CITY OF ALBUQUERQUE

August 11, 2025

**RE: 920 Suneast Dr. SW
Grading & Drainage Plan
Engineer's Stamp Date: 8/6/25
Hydrology File: L09D012B
Case # HYDR-2025-00277**

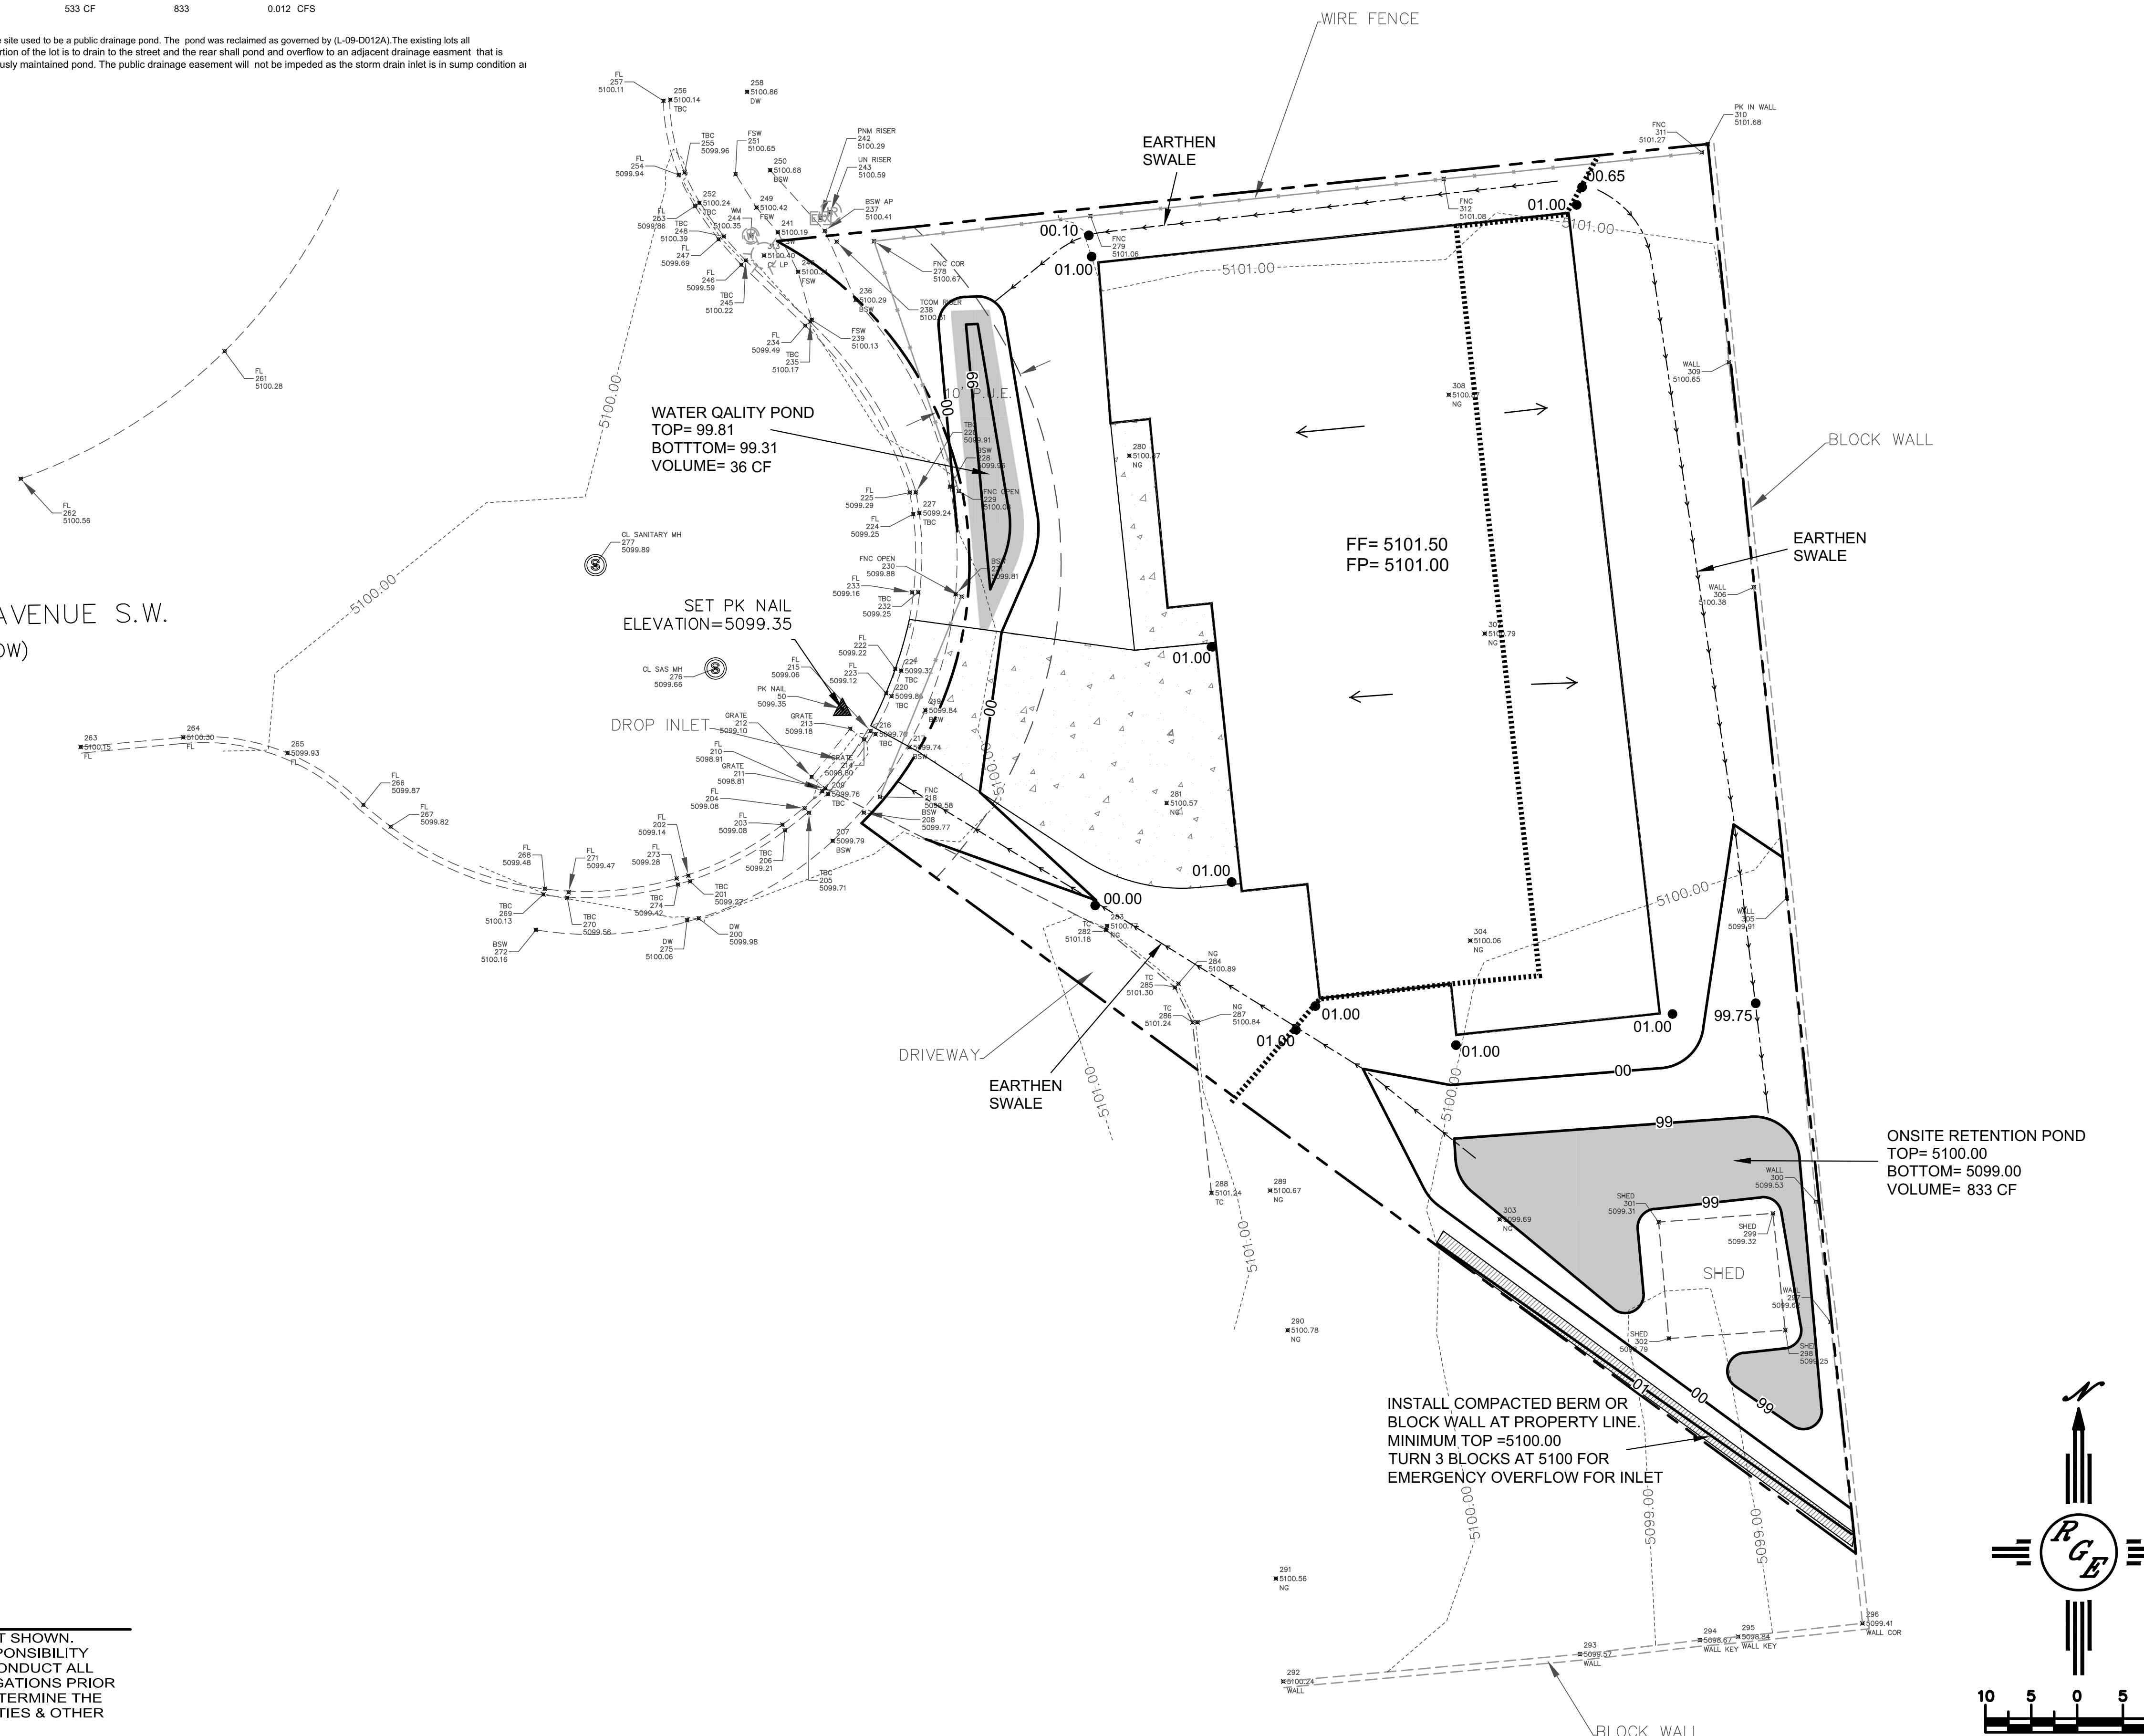
Based upon the information provided in your submittal received 08/06/2025, the Grading & Drainage Plan is approved for Building Permit and Grading Permit. Please attach a copy of this approved plan in the construction sets for Building Permit processing along with a copy of this letter. Please note that a Pad Certification is not required for this site.

1. Engineer's Certification, per the DPM Part 6-14 (F): *Engineer's Certification Checklist For Non-Subdivision* is required.
